# SERVICE SLANTS

## Change Over Instructions For New Type Contact Arm Lever On Model 3031 Wall Box

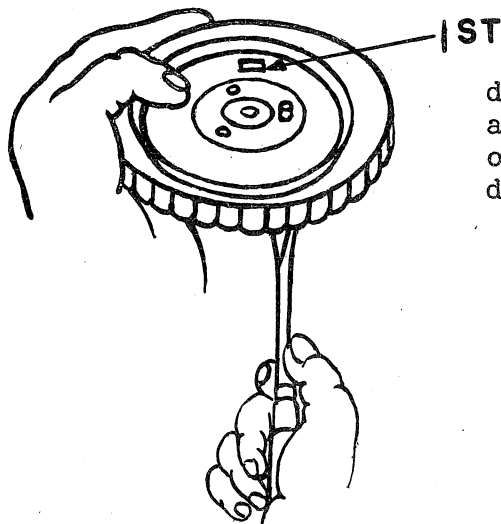
During the course of producing the Model 3031 Wall Boxes, the contact arm lever was changed, resulting in two types of contact arm assemblies that are not interchangeable. If the contact arm assembly requires replacement, either of these two types may be encountered. See sketch below.

If the new straight type, which will be supplied under all orders for Part No. 46128, is used to replace the forked type, it will also be necessary to install the new Part No. 48499 Contact Cover. This cover is part of the Selector Dial Assembly, Part No. 46121.

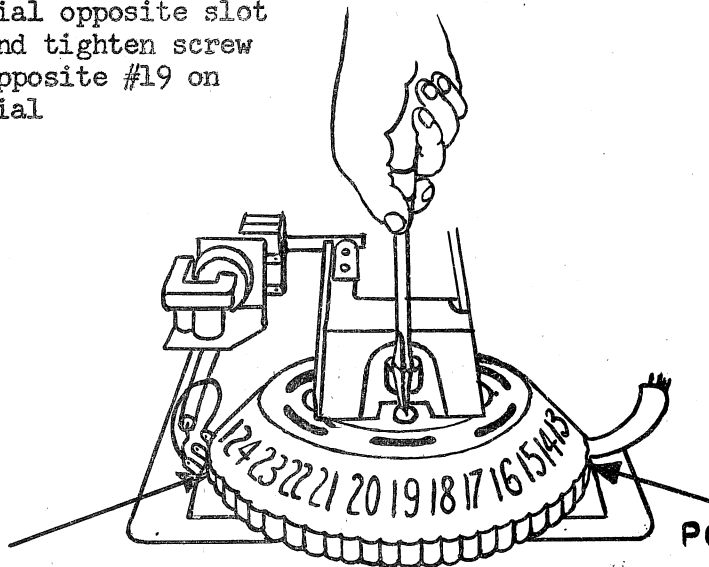
After installing the new contact arm assembly, assemble the contact cover so that the slot centers with #1 on the dial, and tighten the screw opposite #19 on the dial. The other two screws should be in position but remain loose until properly positioned. (See sketch below.)

Assemble the parts in the Wall Box and turn the dial assembly to the #19 selection. Inspect the position of the contact arm with respect to the contact segment assembly. (See "A" in sketch below.) Adjust so that contact arm point is on center of the contact, by loosening the one screw opposite #19 on the dial, if necessary to position the contact properly. Tighten the screw and turn the dial 180° and inspect at the opposite side. (See "B" in sketch below.) If the contact point on the arm does not center on the contact at this position, repeat the above adjustment, equalizing the difference to assure good contact in both positions "A" and "B".

Center #1 on dial opposite slot and tighten screw opposite #19 on dial

Rotate dial 180° and check for centering of contact arm on contact of segment assembly in this position

Center contact arm on contact of segment assembly and tighten screw opposite #19 on dial

If contact arm does not center in both positions equalize difference and tighten other two screws
